Docket Number:	15-AFC-01
Project Title:	Puente Power Project
TN #:	214005-14
Document Title:	FDOC Appendix L - Comment Letters
Description:	N/A
Filer:	Raquel Rodriguez
Organization:	Ventura County Air Pollution Control District
Submitter Role:	Public
Submission Date:	10/14/2016 11:32:27 AM
Docketed Date:	10/14/2016

Appendix L

PDOC Comment Letters

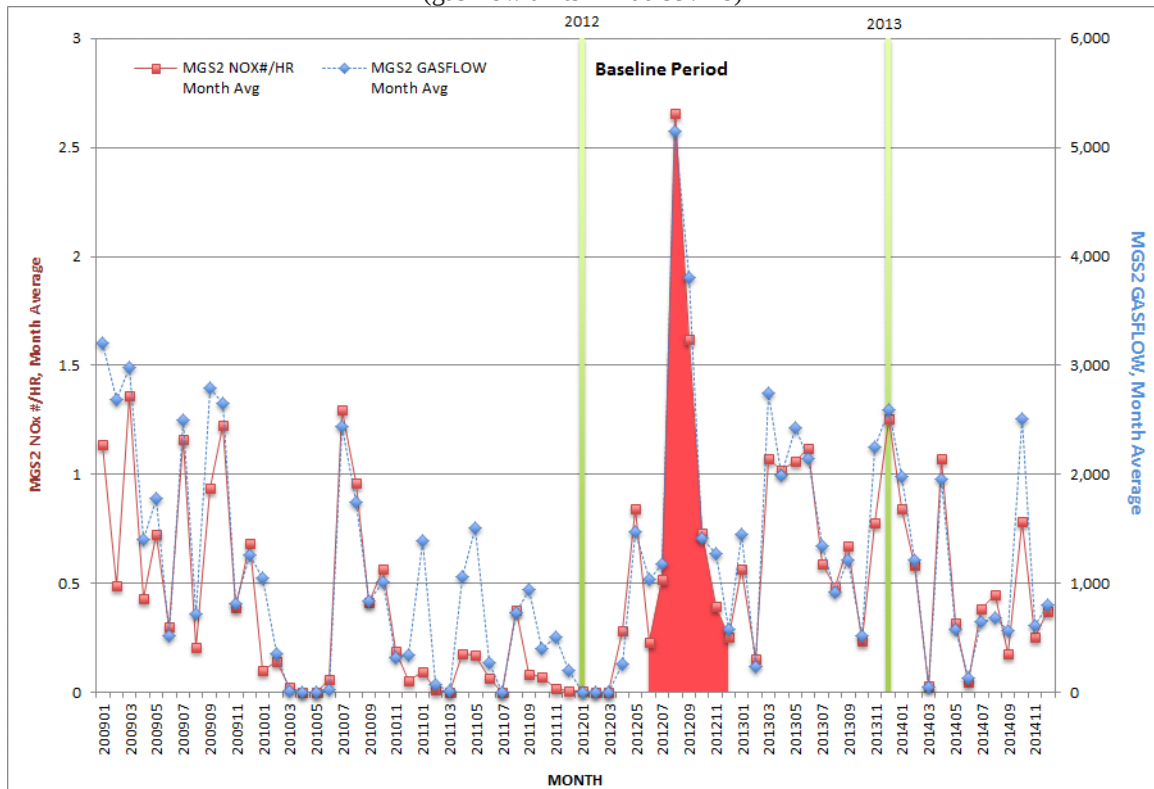
This error is especially problematic because the outdated AP-42 emission factor that NRG used is known to significantly overestimate actual PM emissions from natural gas-fired boilers like Mandalay Unit 2. *See* Attachment A at 6-13. As Dr. Fox notes, this outdated emission factor was based on faulty test methods and EPA does not recommend using it to determine emissions from individual facilities (as NRG has attempted to do here). *Id.* at 8-13. Consequently, using this emission factor to calculate baseline emissions artificially inflates baseline PM2.5 emissions from Mandalay Unit 2.

Agencies have subsequently released other emission factors that more closely represent actual PM2.5 emissions from gas-fired boiler units. *Id.* at 11-14. Dr. Fox’s analysis demonstrates that using *any* of these more accurate emission factors substantially reduces the assumed baseline emissions from Mandalay Unit 2 and shows that NRG must obtain a PSD permit for the Project’s PM2.5 emissions. *Id.* at 9-14.

Figure 1: Comparison of PM_{2.5} as Reported in AP-42 with Recent Measurements Using Improved Testing Methods.⁵²

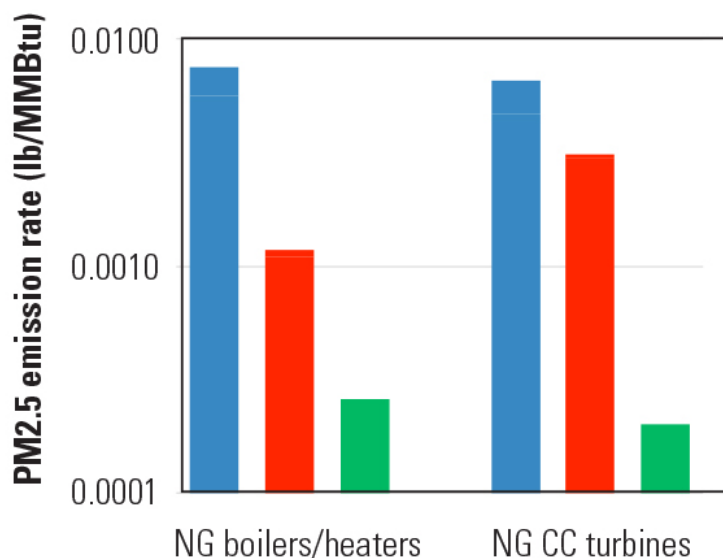
Figure 1 compares the results of these studies with AP-42 emission factors, relied on by the Applicant to establish the baseline. This figure shows that AP-42 emission factors

overestimate actual baseline emissions by significant amounts compared to modern testing methods.

The results of these investigations for gas-fired boilers and steam generators, such as MGS Unit 2, are summarized in Table 3. These revised emission factors have been used in EPA National Emission Inventories and to permit new sources.⁵³ The revised PM_{2.5} emission factor for gas-fired boilers and steam generators (0.35 lb/MMscf⁵⁴) is a factor of seven lower than the AP-42 emission factor of 2.5 lb/MMscf used in the Applicant's PM_{2.5} netting analysis.⁵⁵ Using

this revised PM2.5 emission factor but otherwise using the Applicant's assumptions, yields a net change in PM2.5 emission of **10.4 ton/yr.**⁵⁶ This change alone results in an exceedance of the PM2.5 significance threshold and triggers PSD review for PM2.5.

Figure 2: Monthly NOx and Fuel Use 2009-2014

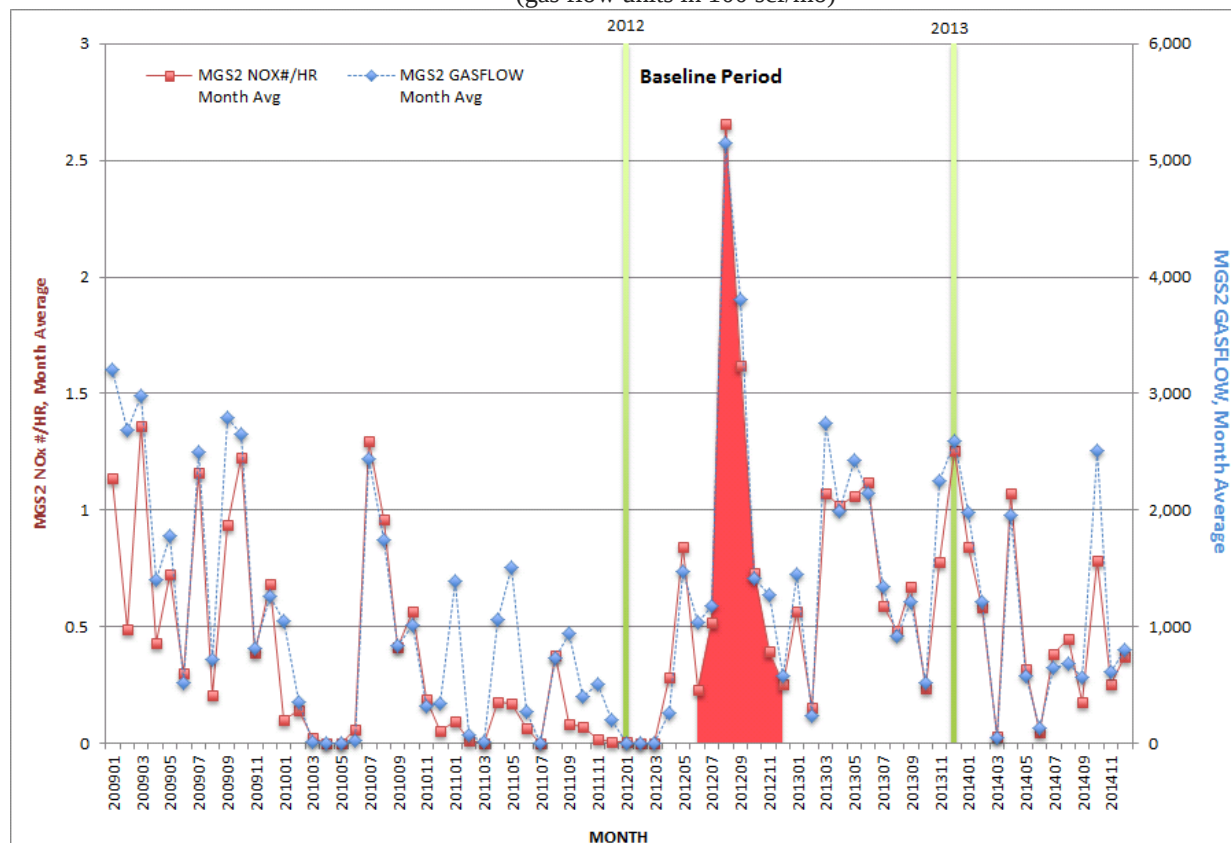
My analysis of the applicant’s NO_x and fuel use CEMS data, summarized in Figure 2, indicates that the 2012-2013 period selected as the baseline is not representative of normal

operation. In fact, it is the two year period that yields the highest baseline emissions for all pollutants, rather than representative baseline emissions.

First, the 2012-2013 period includes a very large spike in August and September of 2012.⁶⁵ A similar spike is not found elsewhere in the record.

Second, my analysis of this data, summarized in Table 4, indicates that the Applicant picked the two year period that yields the lowest net change in PM2.5 emissions from among the four possible consecutive two-year combinations (10.0, 9.63, **9.06**, 9.27 ton/yr). It is not apparent how a spike in fuel use and emissions, including many violations of permit limits⁶⁶ as discussed in Comment section II.B.2.c.ii satisfies VCAPCD Rule 26.6C.

Figure 3. Hourly PM_{2.5} Emissions from MGS Unit 2.⁷¹

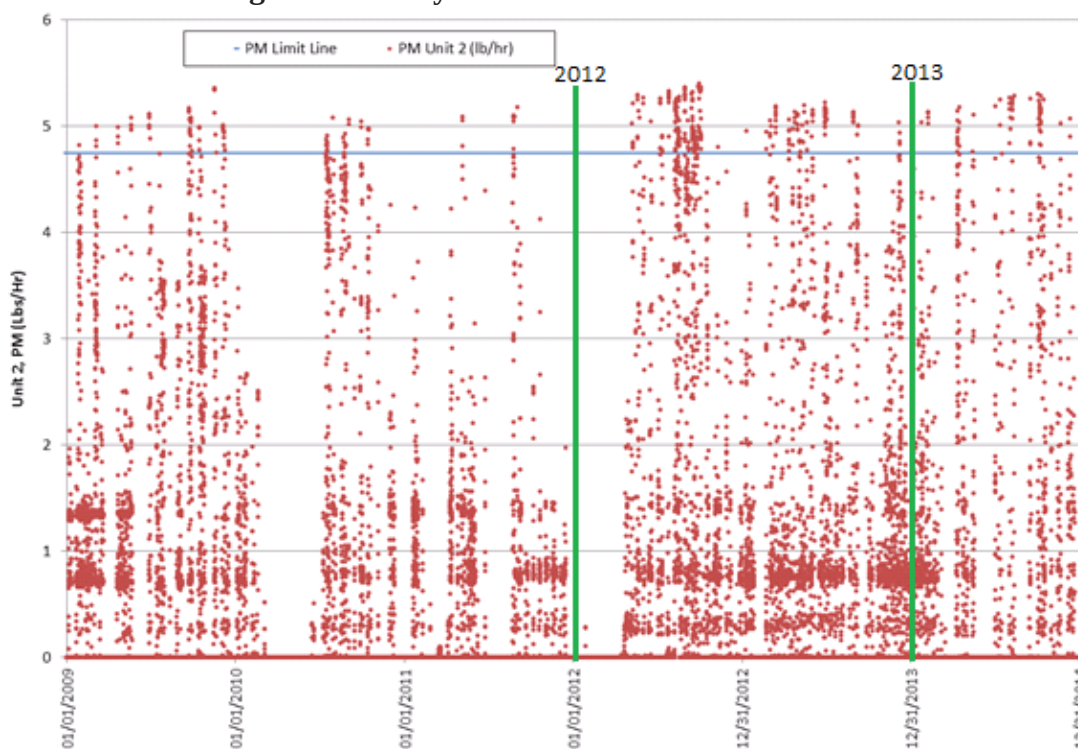
⁶⁹ VCAPCD Permit, Table 4, pdf 32. This table limits hourly emissions from MGS Units 1 and 2 combined to 9.48 lb/hr, or 4.74 lb/hr for each unit.

⁷⁰ In the two years from 2012 – 2013, Unit 2 operated 11,187 hours. There were 452 PM violations (PM>4.74 lb/day) during 2012 -2013. Because each violation accounts for one hour, 452 hr / 11,187 hr = .0404, which rounds to 4%.

Further, MGS Unit 2 is permitted as a Babcock & Wilcox natural gas steam generator with a maximum heat input of 1990 MMBtu/hr.⁷² The Applicant's CEMS data also indicates that the unit operated at higher maximum heat inputs during the baseline period.
